MAS003291 MSC 22-49

Service Campaign 529

MC20 - Installation of new auxiliary pulley for water pump

DATE: November 17, 2022

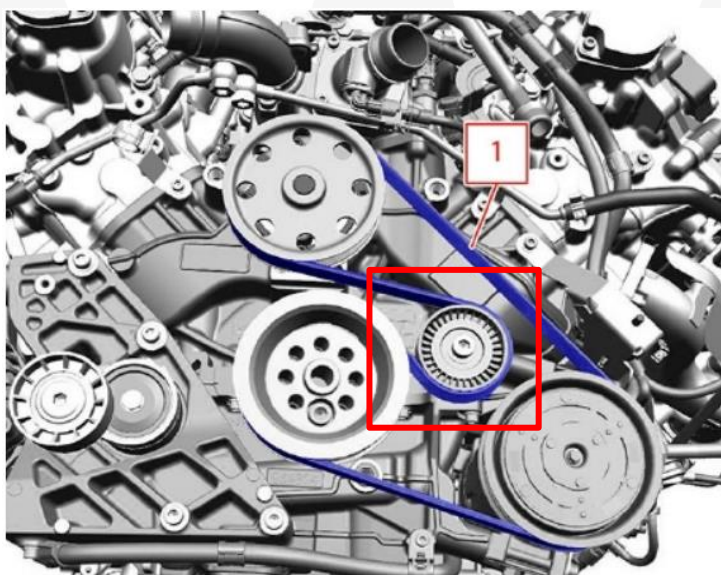
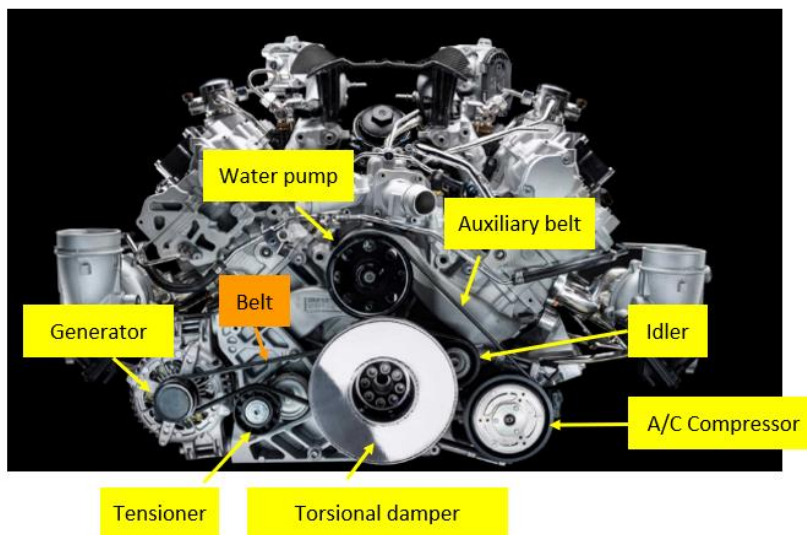
This operation is necessary to introduce a new auxiliary pulley, which improves the performance of the belt loop. The resulting benefit relates only to improved performance in terms of the service life of affected components such as the water pump.

2. During scheduled servicing, when replacing the compressor drive belt, install the new belt tensioner pulley (part. #1 in the figure) following the procedure described:

Description	PN
Auxiliary pulley	670054341
Bushing	670050111
